Wollongong Local Planning Panel Assessment Report | 11 February 2020

WLPP No.	Item No. 3
DA No.	DA-2019/756
Proposal	Mixed use - demolition of existing dwellings and excavation works, construction of mixed use development with basement carparking
Property	65 - 67 Walker Street, HELENSBURGH NSW 2508 Lots 17 and 18 Sec B DP 2205
Applicant	Environa Studio
Responsible Team	Development Assessment and Certification – City Wide Planning Team (MB)

ASSESSMENT REPORT AND RECOMMENDATION

LEVEL 2 PLAN
1:200 @ A3

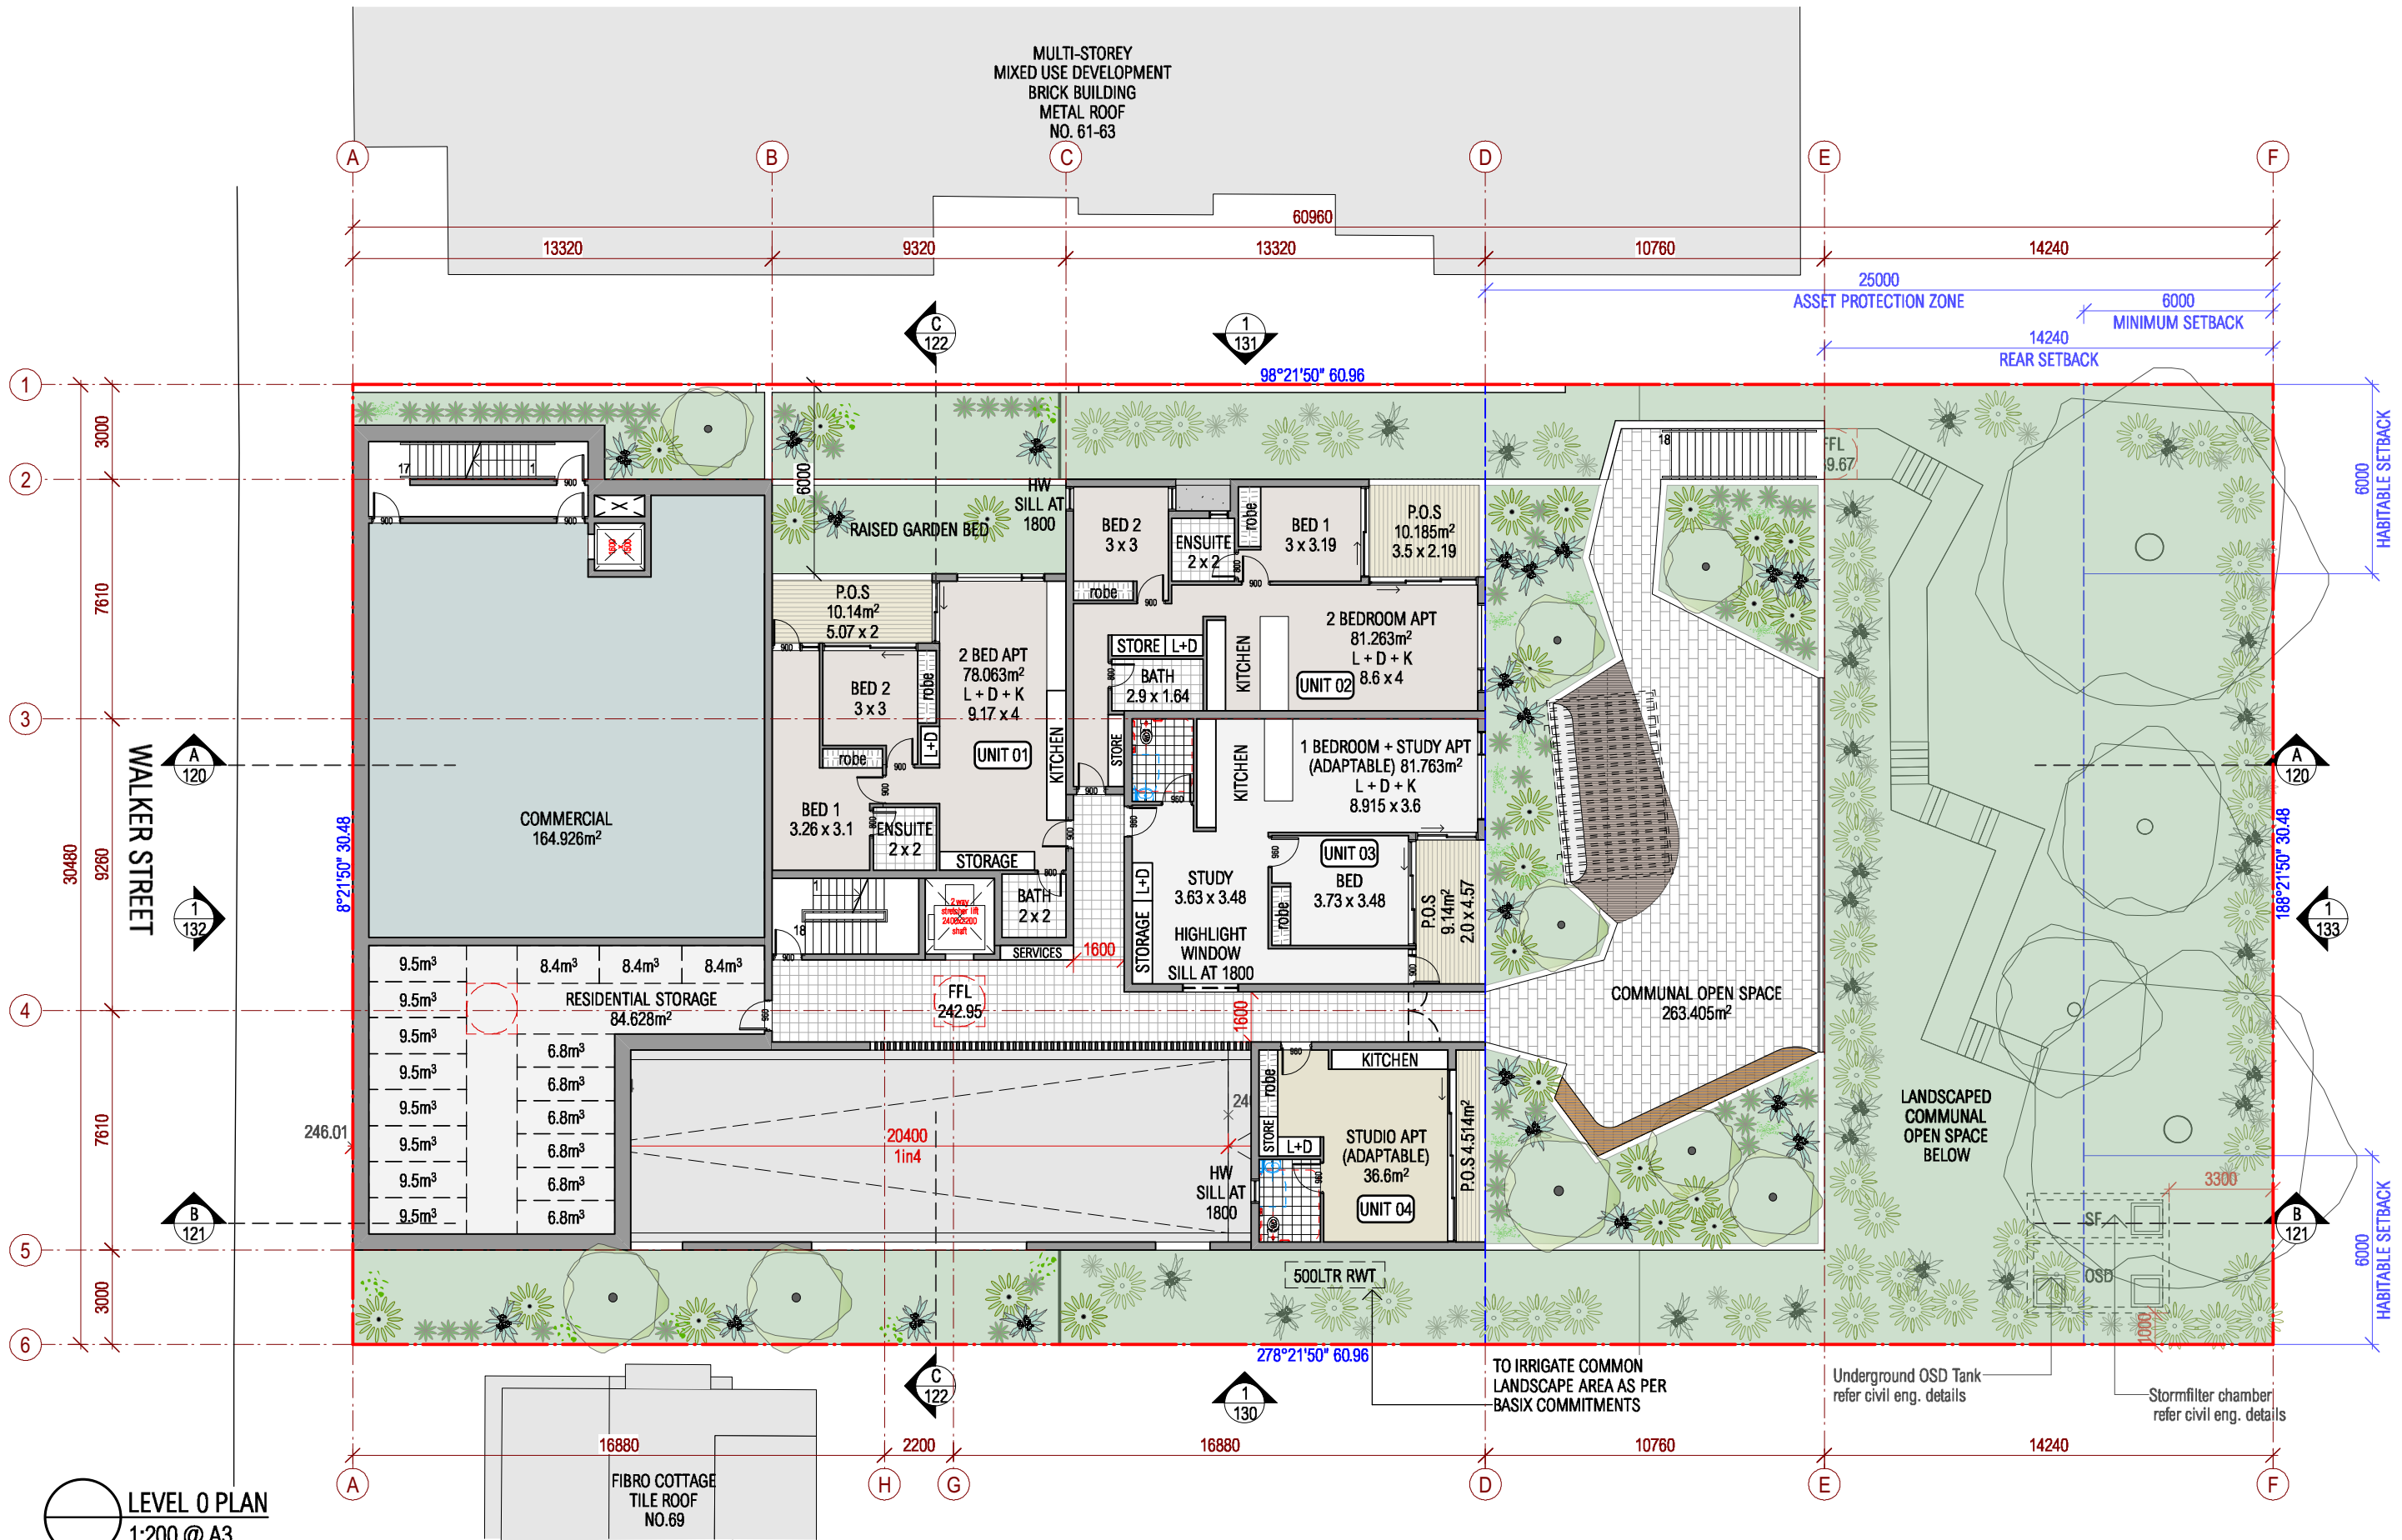
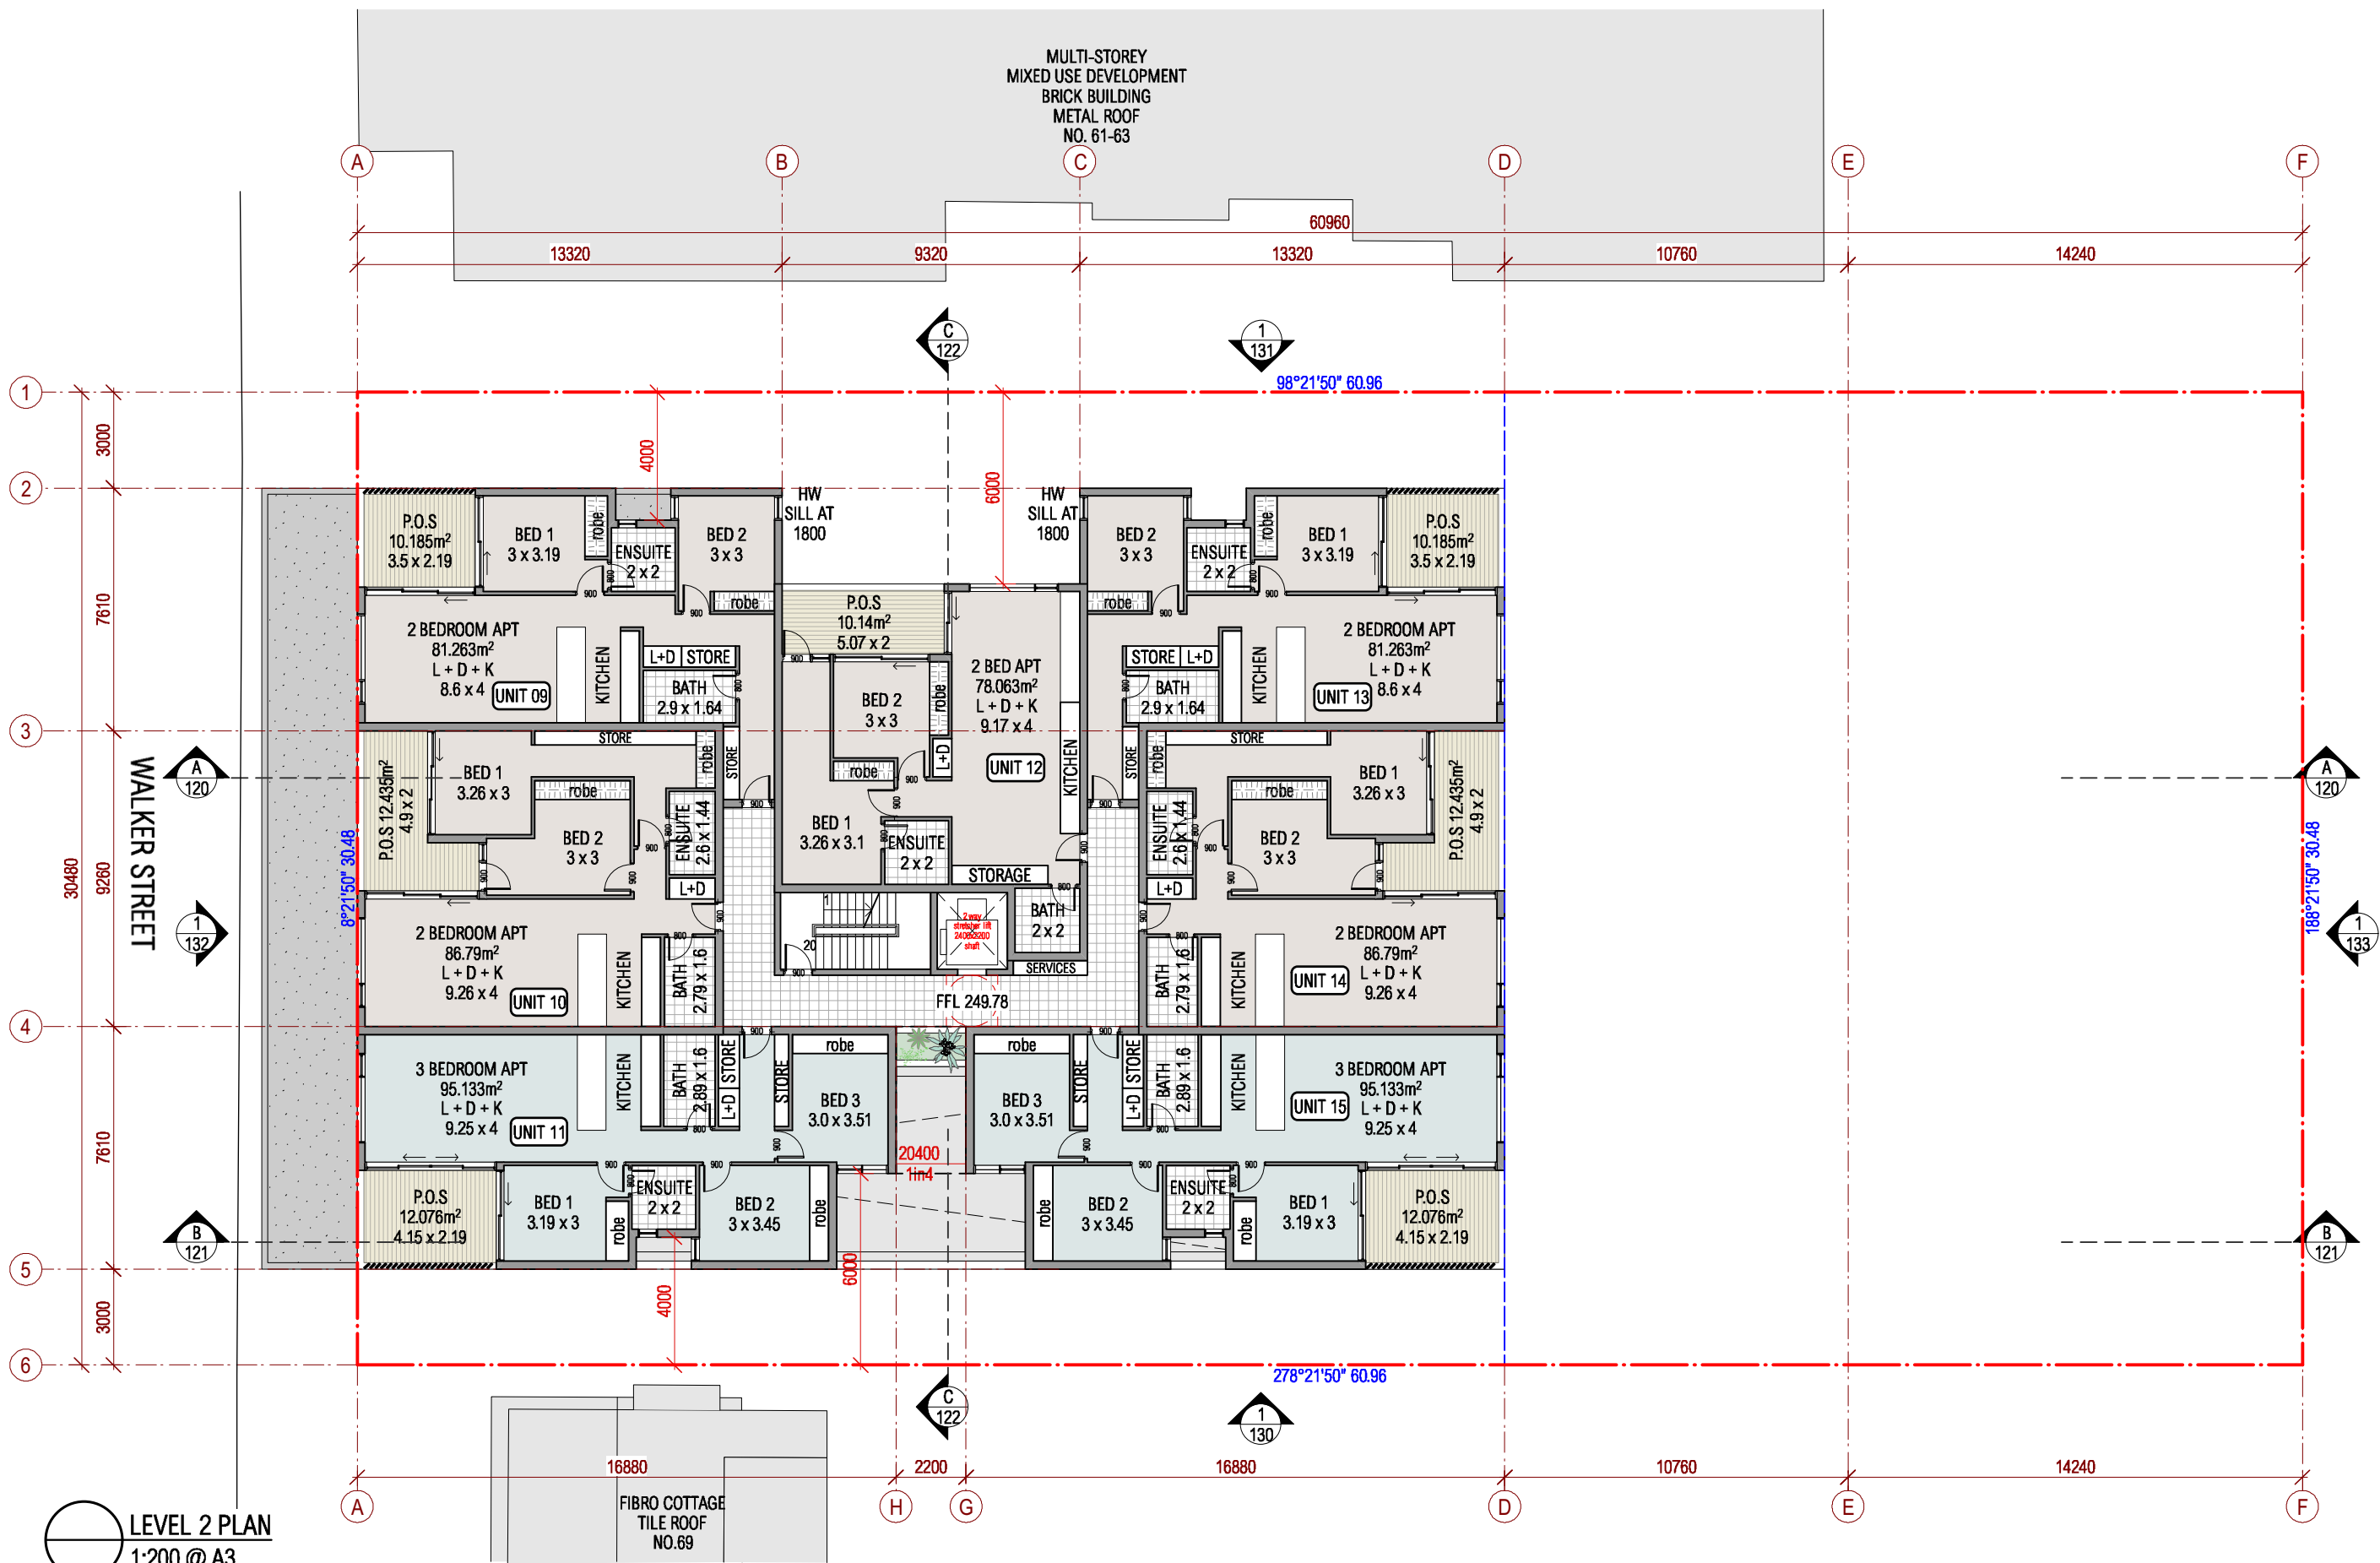
Design Review Panel Comment	Response
<p>Potential undercroft, light, structural and aesthetic issues were identified with Units 8, 11, 1 and 17.</p> <p>The nil setback of the car park to the southern boundary was identified as an issue as it will create a wall up to two storeys in height.</p> <p>The Panel recommended that the ground floor retail be setback 2-3 metres from the northern boundary to contribute to a clear break in the street that allows views to the bushland beyond.</p>	<p>beyond and a landscaped interface with the neighbour.</p>
Density	
<p>The Panel noted that the Bushfire Asset Protection zone has compressed the development westward. This, together with the height limit has constrained the achievable GFA to below the maximum WLEP FSR permitted.</p>	<p>Noted. No amendment required.</p>
Sustainability	
<p>A rainwater tank is noted on the plans to be used to irrigate common landscape areas as in the Basix commitments.</p> <p>The design statement refers to solar collectors for the hot-water system. The panel commends the inclusion of 8KW solar power in the Basix commitments. The location of the PV panels should be shown, and the application of this system clarified.</p>	<p>The location and size of the proposed rainwater tank is noted on Drawing 102.</p> <p>8kW PV panels have been incorporated on Drawing 110.</p>

Extract from Height Plane Diagram 1 (Drawing 906 prepared by Environa Studio)

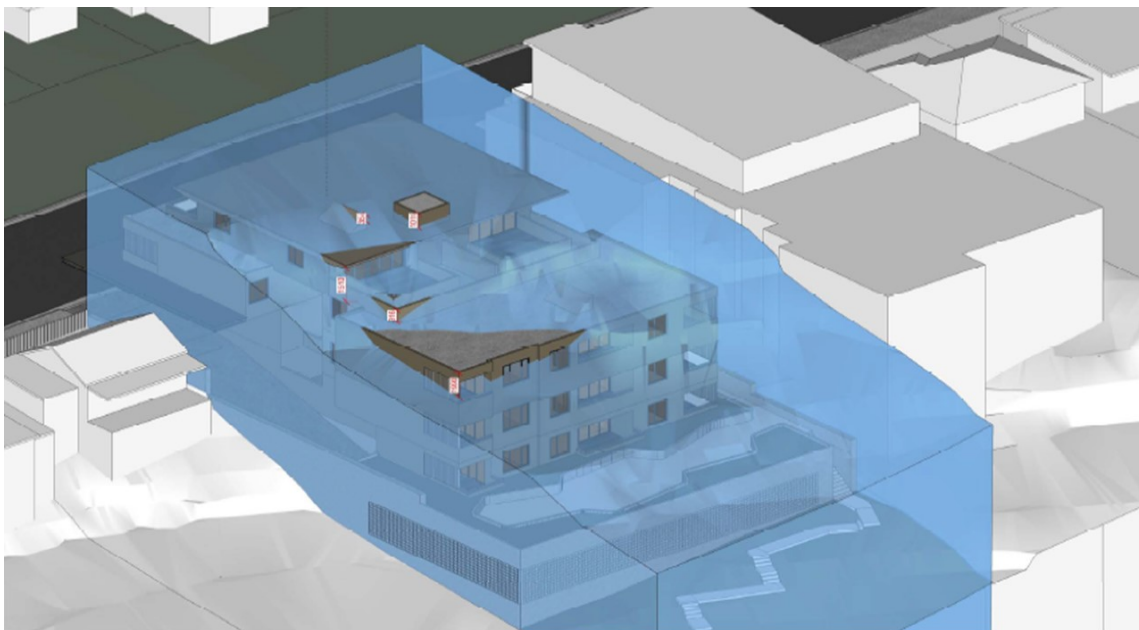
- The highlight window over the living area of Unit 17 exceeds the height variation by up to 355mm.
- The lift overrun exceeds the height limit by up to 1.015 metres. The maximum extent of the non-compliance occurs on the eastern side of the lift overrun. Section CC shows that the western side of the lift overrun exceeds the standard by between 374 and 461mm.
- The eave of the roof of Apartment 17 exceeds the 12 metre standard by up to 1.510 metres and the balustrade to the terrace area of Unit 17 by up to 916mm.
- Part of the southern and eastern sides of Apartments 14 and 15 exceed the standard by up to 1.990 metres.
